UNITED STATES PATENT AND TRADEMARK OFFICE

APPLICATION NO.	FILING DATE	FIRST NAMED INVENTOR	ATTORNEY DOCKET NO.	CONFIRMATION NO.
09/871,229	05/31/2001	Yu-Hwa Lo	NOVA-014	1700

Office Action Summary

DETAILED ACTION

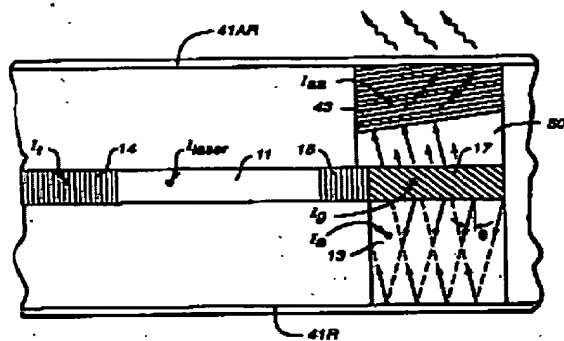
Claims 1-12,17,18,25-27,32-34,39-45 are rejected under 35 U.S.C. 102(b) as being anticipated by Scifres et al (PN 5,103,456).

Figure 8 illustrates a laser system formed within a common substrate, where the system is composed of a laser (11) having a cavity established by reflectors (14) and (15) the emitted light from the laser is deflected by an angled grating (17) towards mirror (41R), where the is reflected towards an output coupler (41AR) or alternatively (43). Output coupler grating (43) provides diffraction of the light, which will change the profile of the output beam. See column 3 lines 10-20, column 6 lines 51-68 and column 7 lines 1-26.

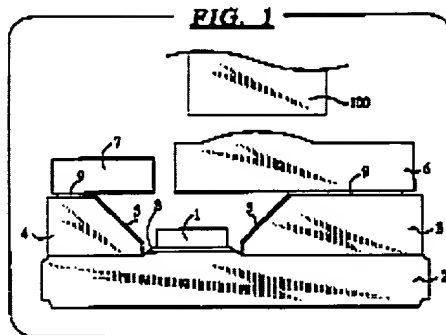
Scrifes et al discloses using an output-coupling grating for diffracting the output light beam, but does not disclose using a lens for providing the output diffraction of the light beam.

Spaeth et al discloses in column 2 lines 45-50 and illustrates in figure 1 the use of a lens (6), which is capable of diffracting or refracting an output light beam from a surface emitting semiconductor laser, therefore it would have been obvious to any person having ordinary skill in the art at the time the invention was made to disposed at the output of a surface emitting semiconductor, as in the laser of Scrifes et al, a lens, as the lens of Spaeth et al, because the lens has the capability of diffracting the output light beam.

Monitoring the light beam of a laser system is well known in the laser art, Spaeth et al discloses in column 2 lines 65-67 and illustrates in figure 1 the use of monitoring chip, which is one of many techniques used for monitoring or detecting the light beam of a laser system.
